PCAP DRMS 2023 Inspection Report and Cost Estimate

RE: Pueblo County Aggregate Project M2016-009 Inspection

RE: M2016-009 Pueblo County Aggregate Project Bond Calculation

44th Lane-Gas Line Offset
8/27/23

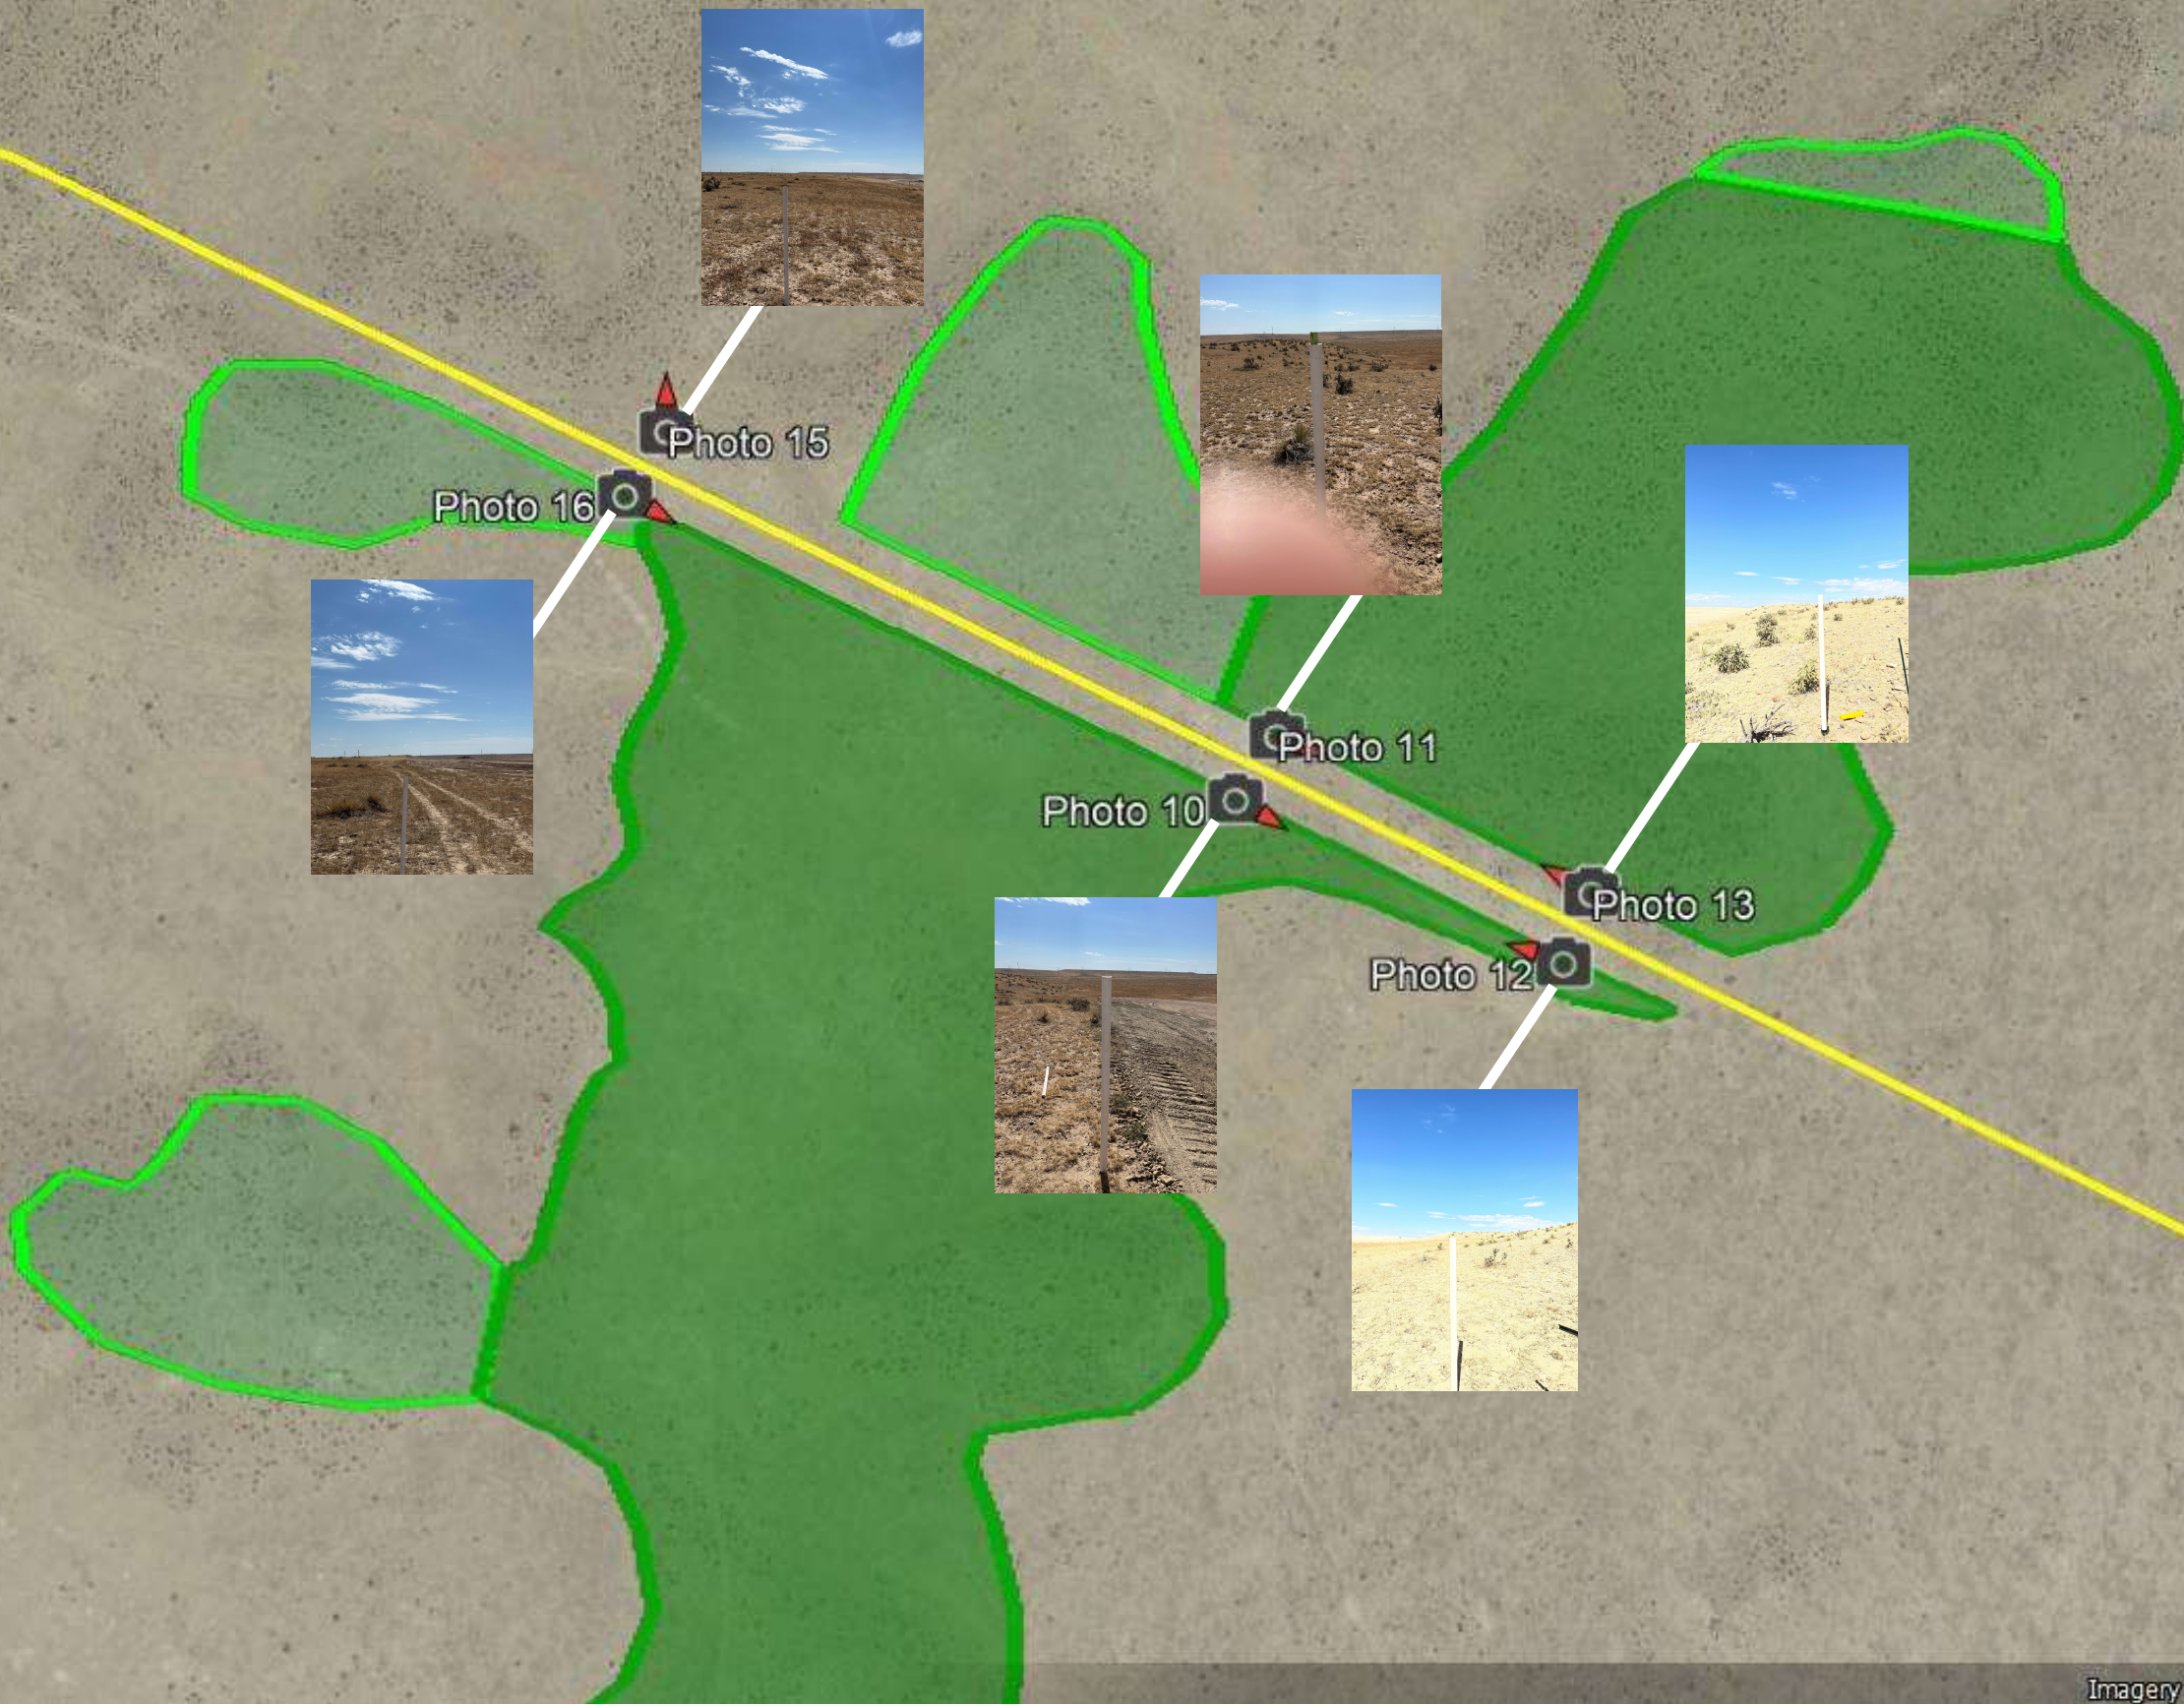
As for Inspection Topic #2, please see the attached documentation of the markers onsite that encompass the CIG gas line. The buffer zone has not changed since Amendment 1.
